In the matter of Proposed Plan Change 92 to Western Bay of Plenty  
Operative District Plan: Ōmokoroa and Te Puke Enabling  
Housing Supply and Other Supporting Matters

**Statement of Evidence of Duncan Barry Tindall for Waka Kotahi – Traffic**

Dated 25 August 2023

Title: **GENERAL ARRANGEMENT**  
 SHEET 1

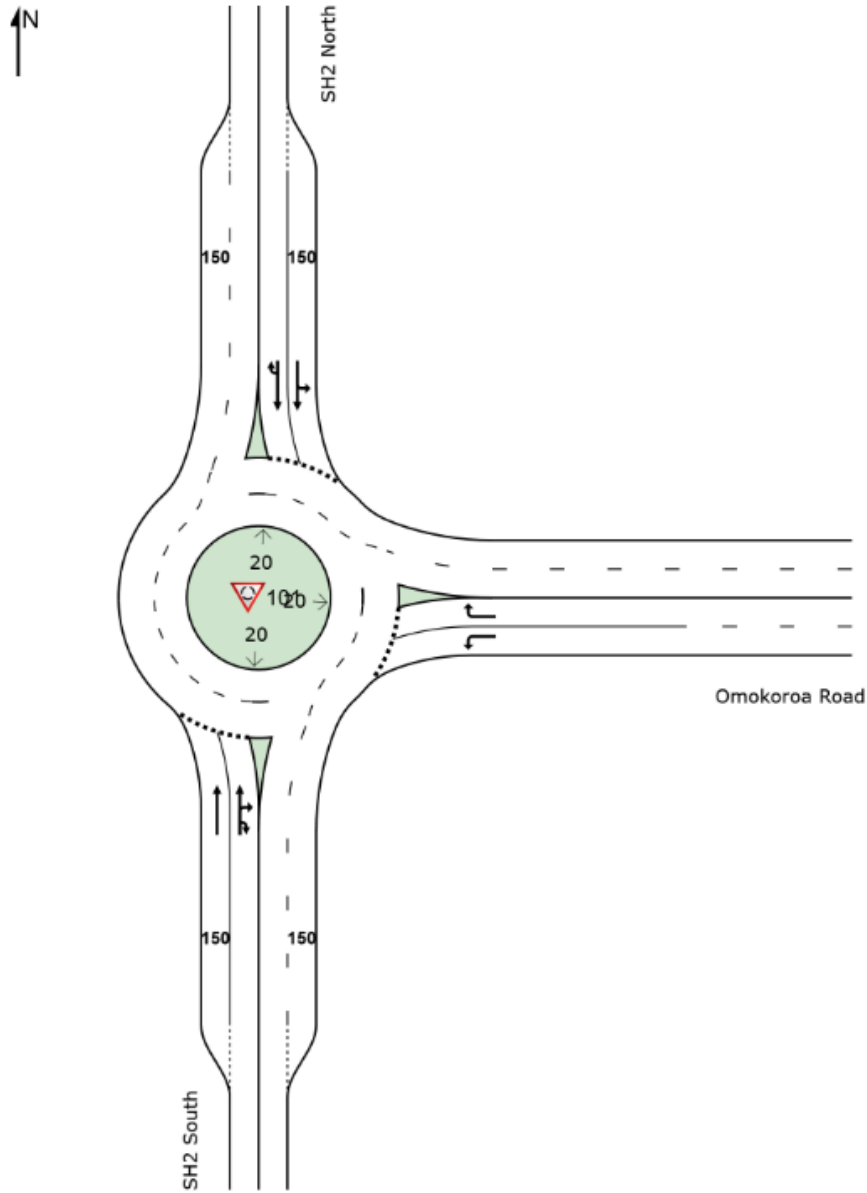
- 10.9 I would also note that the plan provided on 16 August 2023 does not show this second left turn, but the modelling provided is explicit in requiring this double turn. However, I do consider this to be a minor drafting issue on the plan, but confirmation of the intent and commitment of what is being provided would aid clarity in understanding the effects of the proposed PC92 in the context of the infrastructure that will be in place.

- 10.11 In the case of SH2 / Ōmokoroa Road I am aware that there are land issues with the site that means that the space is constrained, and I have not seen any confirmation that the double turn roundabout is viable from vehicle tracking. Therefore, it is my opinion that there is a risk that the analysis on capacity, and therefore forecast delays overestimates the demands

- 11.7 I am concerned that I have not seen any confirmation that the roundabout double left turn is viable from vehicle tracking. Therefore, the effects of the proposed PC92 as it stands has been shown to be mitigated by ensuring an excess of development does not occur prior to the grade separation of the SH2/Ōmokoroa Road intersection. However, this development may be overestimated, if the geographical constraints dictate only a single left turn lane can be accommodated on Ōmokoroa Road, as I demonstrated in Para 10.12.

- 10.13 I consider that this shows the critical nature of the double turn being enabled from Ōmokoroa Road towards Tauranga on SH2.
- 10.14 This risk could be allayed by the provision of a drawing showing the roundabout with tracking on the plan, and the overall design fitting within the land available. Alternatively, there is the potential to add an additional rule in a similar form to that currently proposed that places a trigger on a (lower) development level prior to either TNL stage 2 or a two lane turn roundabout.
